RS-08-138

LaSalle County Station, Units 1 and 2  
Facility Operating License Nos. NPF-11 and NPF-18  
NRC Docket Nos. 50-373 and 50-374

Subject: Additional Information Supporting Request for License Amendment Regarding Spent Fuel Storage Pool Criticality

**ATTACHMENT 1**  
**Response to Request for Additional Information**

**Figure 1:** Examples of Implementing the 3-of-4 and 4-of-4 Interface Configurations

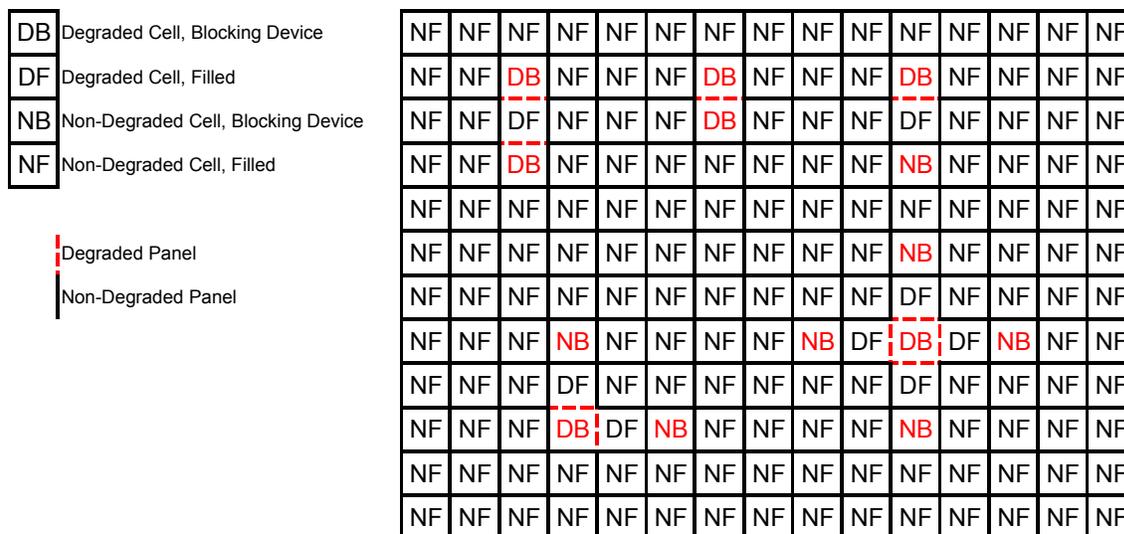
It is not clear that all of the affected 2x2 arrays are being identified. A storage cell is not part of just one 2x2 array. Unless it is on the periphery, each storage cell is at the center of a 3x3 array which comprises four different 2x2 arrays. Additionally, from the description in the LAR, it appears that the Boraflex panels are shared by two cells, meaning the degradation of one panel actually affects two cells, creating a 4-by-3 array of cells with six separate 2x2 arrays. It is not clear whether the adjacent cell is also being identified as 'unusable' and its associated 2x2 arrays being controlled. Provide a description of how the affected 2x2 arrays are being identified and controlled so that the staff may make a reasonable assurance decision that all of the appropriate affected 2x2 arrays are being included.

A single degraded storage panel causes two degraded storage cells, which are then part of six 2x2 arrays. Each of these 2x2 arrays must satisfy the acceptance criteria for either 3-of-4 or 4-of-4 storage. There is no need to consider the 3x3 array with the degraded cell in the center as satisfying the conditions for each 2x2 set of cells that contains a degraded cell is sufficient.

Therefore, in each of the six 2x2 arrays that can be considered containing a degraded storage cell, there must be a blocking device in one of those four cells. In such a configuration, a minimum of two blocking devices would be required (i.e., most likely placed face adjacent to the degraded panel but not necessarily placed face to face as shown below) to satisfy the 3-of-4 storage criteria for each of the six 2x2 arrays created by the degraded panel.

Figure 1 provides several other configurations of degraded storage cells and the requirements for blocking devices. In the figure below, panels that exhibit an unacceptable level of Boraflex are designated by a dashed line. Boraflex panels that do not exhibit an unacceptable level of

Boraflex are designated by a solid black line. The first letter in each cell specifies whether a storage cell is considered degraded (D) or not degraded (N). A storage cell is considered degraded if one or more of the four surrounding Boraflex panels are considered degraded to an unacceptable level. The second letter in each cell specifies whether the storage cell contains a blocking device (B) or is filled with spent fuel (F).

**Figure 3:** Calculational Model of Eccentric Positioning as Drawn by the Two-Dimensional Plotter in MCNP4a

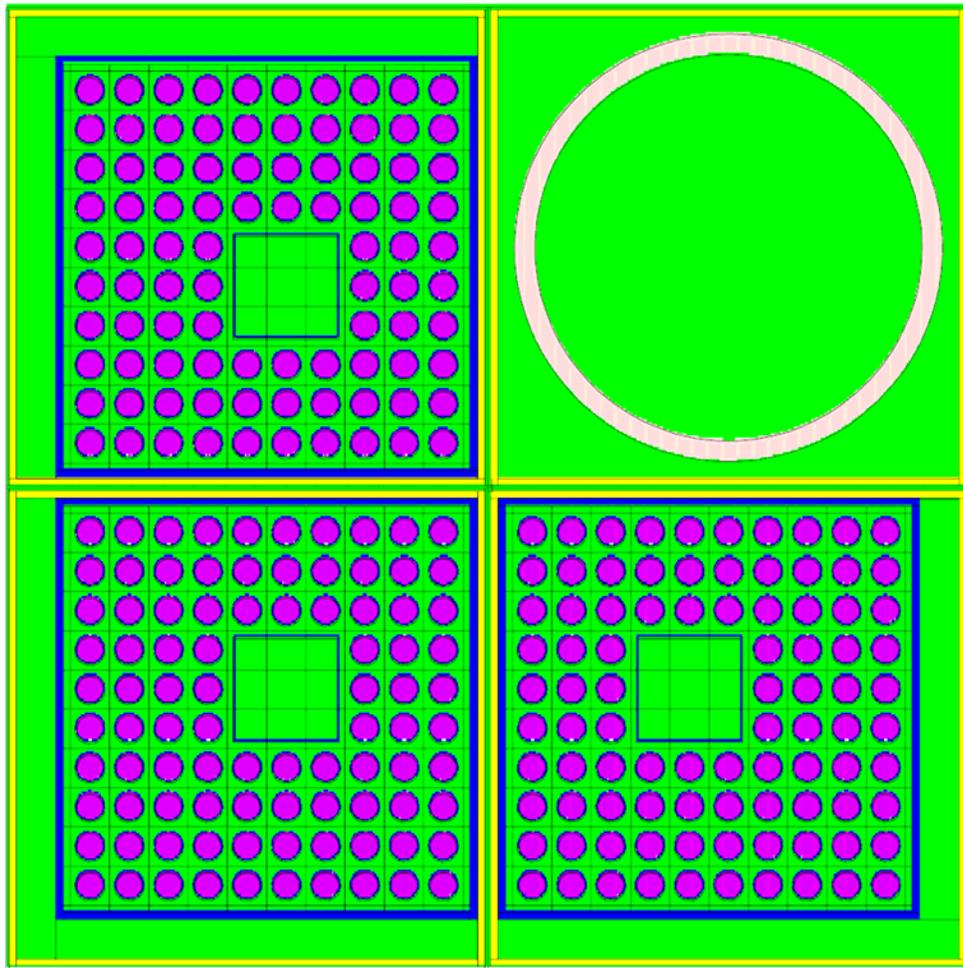
- a) The nominal calculations have the FA centered in the cell. For the eccentric positioning determination the analysis states, "MCNP-4A calculations were made with the fuel assemblies assumed to be in the corner of the storage rack cell. These calculations indicate that eccentric positioning results in a decrease in reactivity." The discussion leaves out several pertinent details. Are they all pushed into the same corner? That would essentially keep the distance between them constant. Are they all pushed into the corner which brings them closest together? Since it is a 2x2 array modeled as infinite, even that essentially keeps the net separation the same. What if not all of the assemblies are pushed into the corner? Does it matter which ones are? What if the 3-of-4 storage configuration is surrounded by 4-of-4 storage configurations, or vice versa? Provide the necessary details for the staff to independently reach a reasonable assurance determination regarding eccentric fuel positioning.

- b) The analysis concludes that centering the fuel assemblies in the cells is the most reactive configuration. Since the channel takes up space in the cell it effectively reduces the amount of eccentricity that can be achieved by the model. Would increased eccentricity affect the conclusion? Are these independent parameters?

The eccentric positioning calculations consider that each group of three assemblies (i.e., 2x2) is clustered together as shown in Figure 3 below. Periodic boundary conditions simulate an infinite array of eccentrically located fuel assemblies, clustered in groups of three. The blocking device is not considered to be eccentrically positioned because movement of the blocking device within the cell would have a negligible effect on reactivity. Eccentric positioning does not result in an increase in reactivity because although the assemblies are placed closer to one another in one location, it creates a larger water gap between other adjacent assemblies. The distribution of 3-of-4 and 4-of-4 storage patterns in the SFP would not effect the conclusion that eccentric positioning does not increase the reactivity.

The presence of the channel would restrict the amount of eccentricity possible. However it should be noted that the absence of the channel would result in a decrease in the reactivity by 0.0076  $\Delta k$ . Any reactivity effect of additional eccentricity because of the missing fuel channel is not expected to have any additional reactivity effect and would be offset by the absence of the channel.
